UNITED STATES PATENT AND TRADEMARK OFFICE

APPLICATION NO.	FILING DATE	FIRST NAMED INVENTOR	ATTORNEY DOCKET NO.	CONFIRMATION NO	
10/600,479	06/19/2003	Seiya Asano	3702/0M969US0 6321		
7278	7590 07/30/2004		EXAMINER		
DARBY & DARBY P.C. P. O. BOX 5257			NGUYEN, XUAN LAN T		
	, NY 10150-5257		ART UNIT	PAPER NUMBER	
			3683		
			DATE MAILED: 07/30/2004

DETAILED ACTION

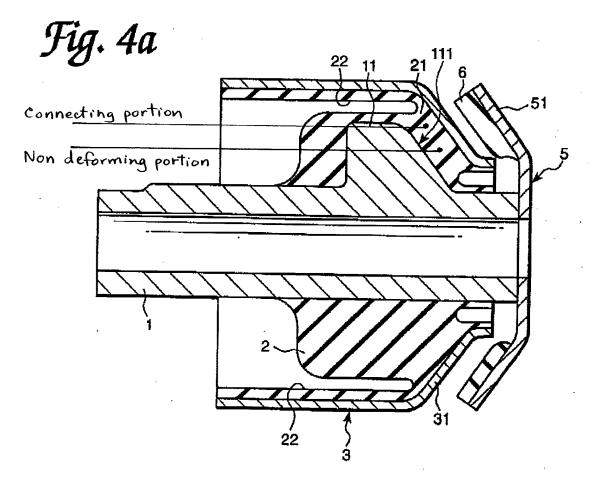
- (b) the invention was patented or described in a printed publication in this or a foreign country or in public use or on sale in this country, more than one year prior to the date of application for patent in the United States.
- 4. Claims 1-3 are rejected under 35 U.S.C. 102(b) as being anticipated by Hadano et al.

Re: claim 1, Hadano shows a vibration isolating bushing, as in the present invention, comprising: a main shaft member 1, 5 including a tubular portion 1, a flange portion 5 extending radially outwardly from one end of the tubular portion, and a block portion 11 provided on a central portion of the tubular portion and distanced from the flange portion an axial direction of the main shaft member; an outer cylinder member 3 disposed coaxially on an outer side of the main shaft member distance therefrom; and a rubber elastic body 2 disposed between the main shaft member and the outer cylinder member integral connection of the main shaft member and the outer cylinder member, rubber elastic body including a hollow portion 22 which is open in an end face away from the flange portion and extends in the axial direction up to the vicinity of an end face on a side the flange portion; wherein the rubber elastic body further includes non-deforming rubber portion, please see the figure below, and a connecting portion, see the figure below; the non-deforming rubber portion is positioned between the flange portion and the block portion and is substantially undeformable with respect to an

application of an axial load; the connecting portion is positioned between a bottom the hollow portion and the end face of the rubber elastic body on the side of the flange portion, for connecting the non-deforming rubber portion and an inner peripheral surface of an end portion of the outer cylinder member.

Re: claim 2, Hadano shows the block portion 11's radially outwardly protruding end face as claimed.

Re: claim 3, Hadano further shows the connecting portion to be offset inwardly compared to the non-deforming portion.
